ANTELOPE VALLEY SALT/NUTRIENT MANAGEMENT PLAN STAKEHOLDER MEETING MINUTES

September 18, 2013

Draft SNMP Comments

ATTACHMENT C

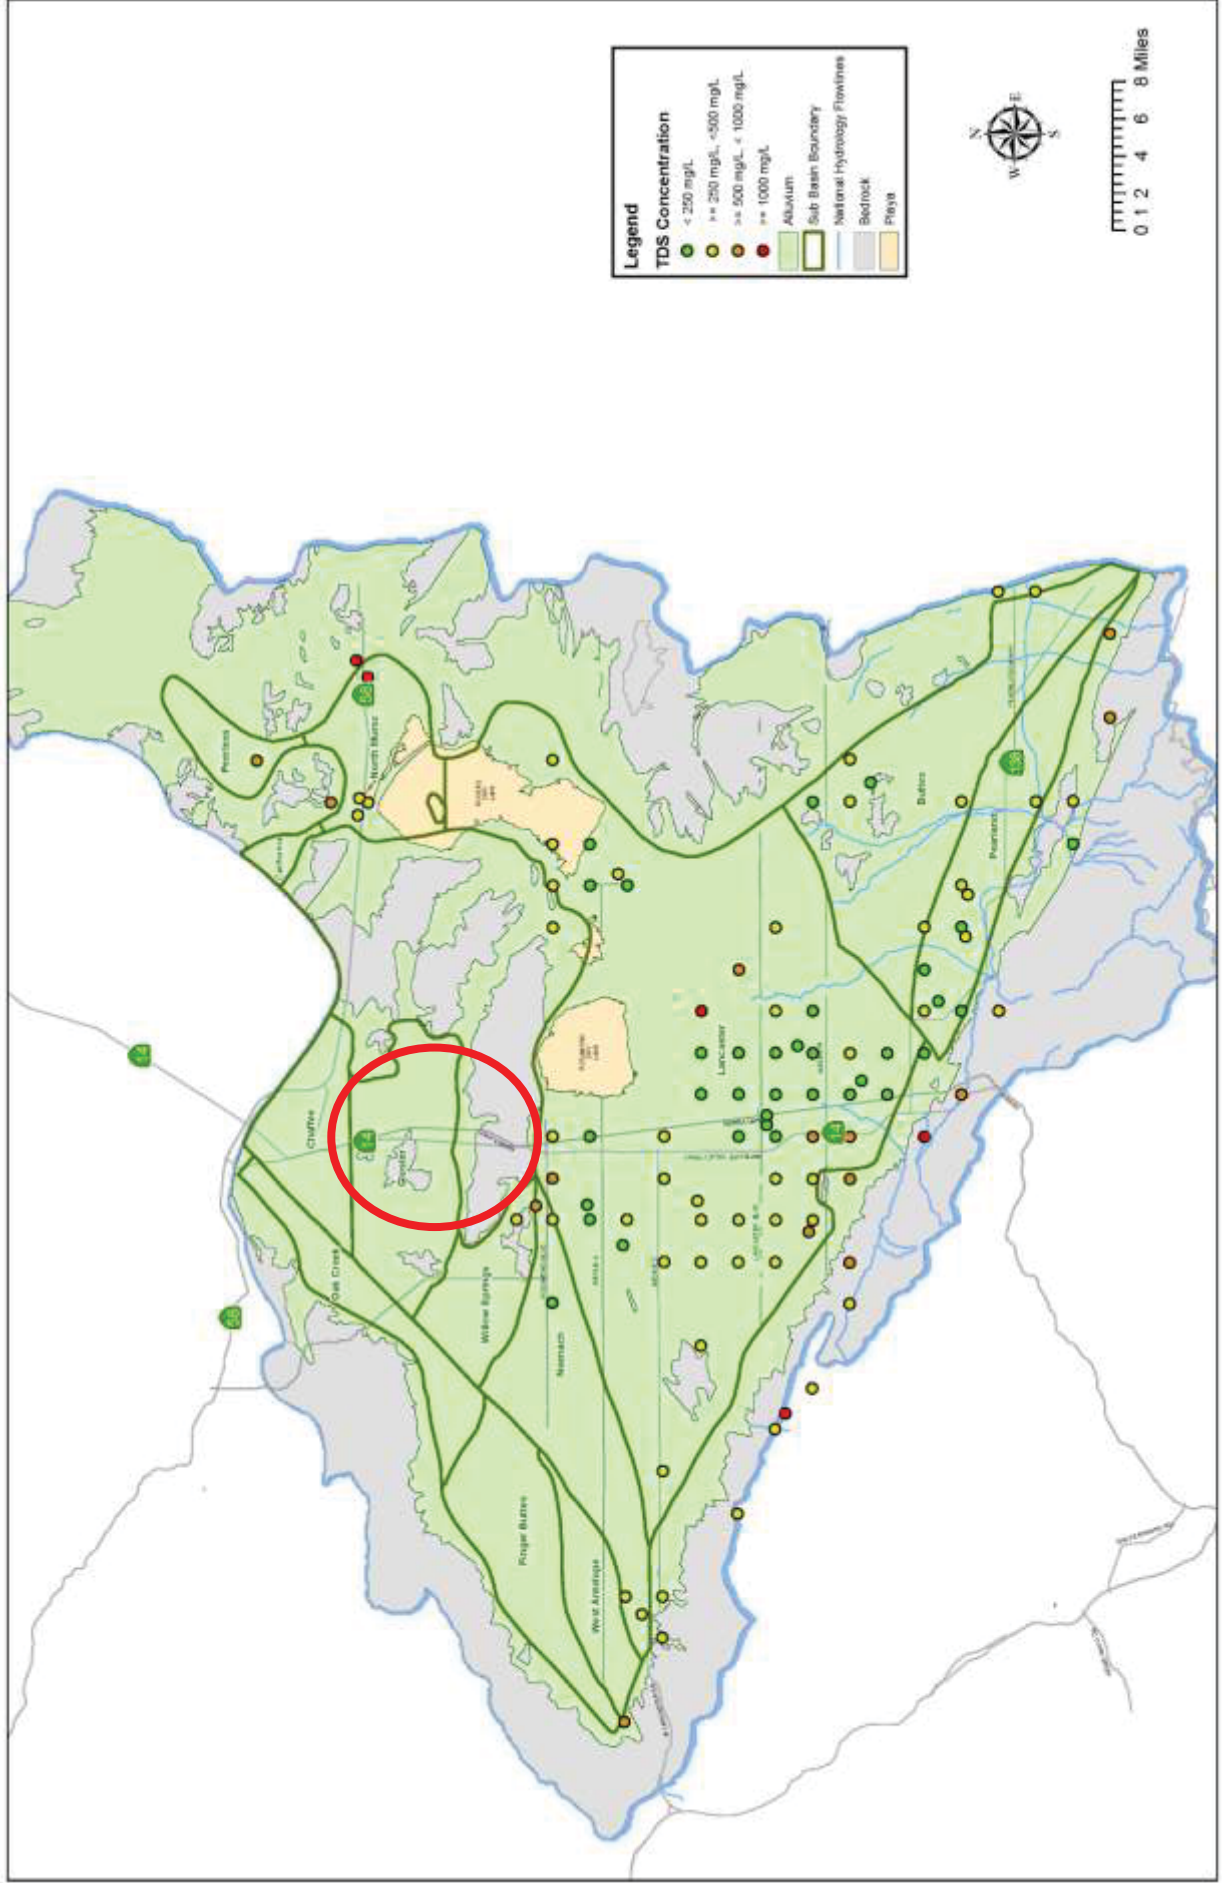
The data inconsistency is due to the discrepancy in boundary delineation shown in GAMA and DWR Bulletin 118 for the Antelope Valley Groundwater Basin (6-44). The red circles on Attachments C (DWR sub-basin boundary) and D (from GAMA website) show the boundary difference. The boundary shown on Attachment D does not include the Gloster or Chaffee sub-basins. Baseline water quality in the revised SNMP will include the GAMA and USGS datasets combined.
